**From:** Dennis Dettloff [DDettloff@deltaenv.com]  
**Sent:** Thursday, December 20, 2007 11:23 AM  
**To:** Wickham, Jerry, Env. Health  
**Subject:** 1771 First Street, Livermore

Subject: Fuel Leak Case No. RO0000436 and Geotracker Global ID T0600101777, Unocal #4186, 1771 First Street, Livermore, CA 94550

Alameda County Environmental Health (ACEH) staff has reviewed the fuel leak case file for the above-referenced site including the recently submitted document entitled, "Work Plan Addendum," dated October 30, 2007. The Work Plan Addendum appears to be as an addendum to a previous document entitled, "Work Plan for Additional Ozone Injection Well Installation," dated July 12, 2007. When submitting an addendum in the future, please clearly identify the original document in the introduction section of the addendum. The "Work Plan for Additional Ozone Injection Well Installation," dated July 12, 2007 proposed the installation of seven additional ozone sparge wells within the middle water-bearing layer typically encountered roughly 35 to 45 feet bgs. The Work Plan Addendum presents plans for decommissioning of eight ozone sparge wells, installation of four ozone sparge wells to rep

# Attachment A: Revised Figure 2

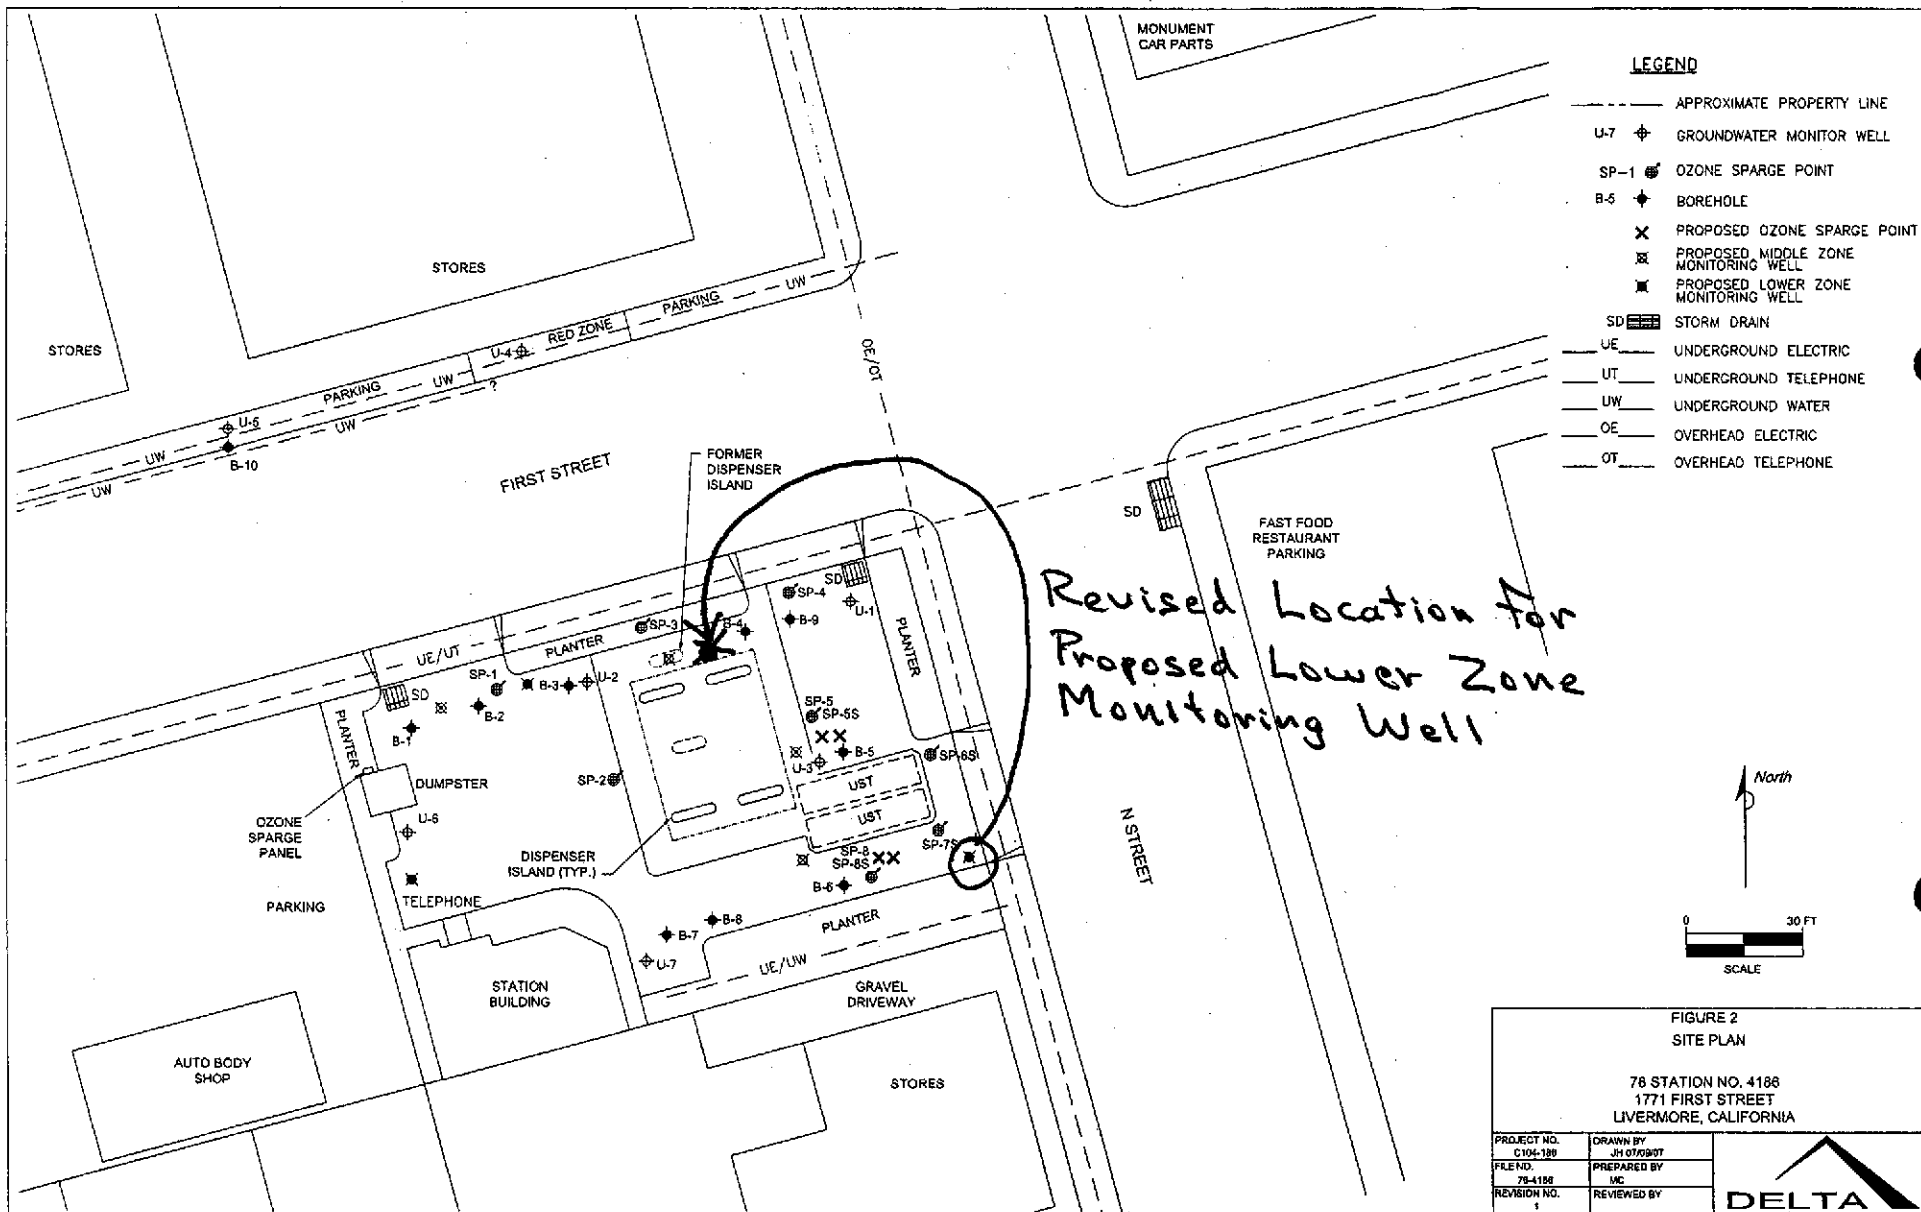
1. **Proposed Groundwater Monitoring Wells.** The proposed methods for groundwater monitoring well installation are generally acceptable. However, we request that the proposed lower zone monitoring well upgradient of the USTs be moved to a downgradient location as shown on the attached Revised Figure 2.

2. **Number of Proposed Ozone Injection Wells.** Figure 2 of the Work Plan Addendum only shows proposed locations for the four ozone sparge wells proposed in the Work Plan Addendum and does not show the seven sparge wells proposed in the Work Plan dated July 12, 2007 Work Plan. In the Work Plan for Additional Ozone Injection Well Installation dated July 12, 2007, a total of seven sparge well were proposed within the middle water-bearing zone. In the October 31, 2007 Work Plan Addendum, two additional sparge wells were proposed in the middle water-bearing zone. However, it appears that both the July 12, 2007 Work Plan and October 31, 2007 Work Plan Addendum propose sparge wells at the same location adjacent to well U-3. Therefore, it appears that eight additional sparge wells are actually proposed in the middle water-bearing zone. For clarity and completeness, please show all proposed sampling locations on one map in the Revised Work Plan requested below.
